Office Action Summary

10/591,887

FLETCHER, RICHARD EDMOND

This figure, now referred to as Schram annotated Fig. 1, used for the rejection of claims 4 and 13 has been replicated below, and the Examiner has added reference points for ease of explanation, and said reference points will be used for the rejection of claims 4 and 13 below.

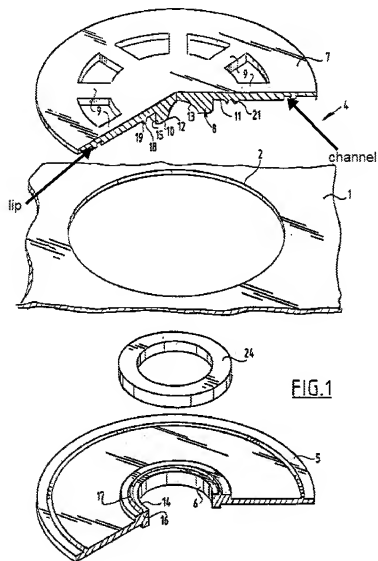
As to claim 4, Schram teaches a fitting as claimed in claim 2 or claim 3 wherein the flange is provided with an annular channel (channel, Schram annotated Fig. 1).

As to claim 13, Schram teaches a fitting as claimed in claim 2 wherein at the location of the joint of the resiliently deformable part (laterally extending wings 9) with the flange (Fig. 3a) there is provided an annular lip (lip, Schram annotated Fig. 1) for locating the fitting within an aperture of the membrane and which upon melting welds the edges of the aperture to the fitting (col. 2, lines 10-14).
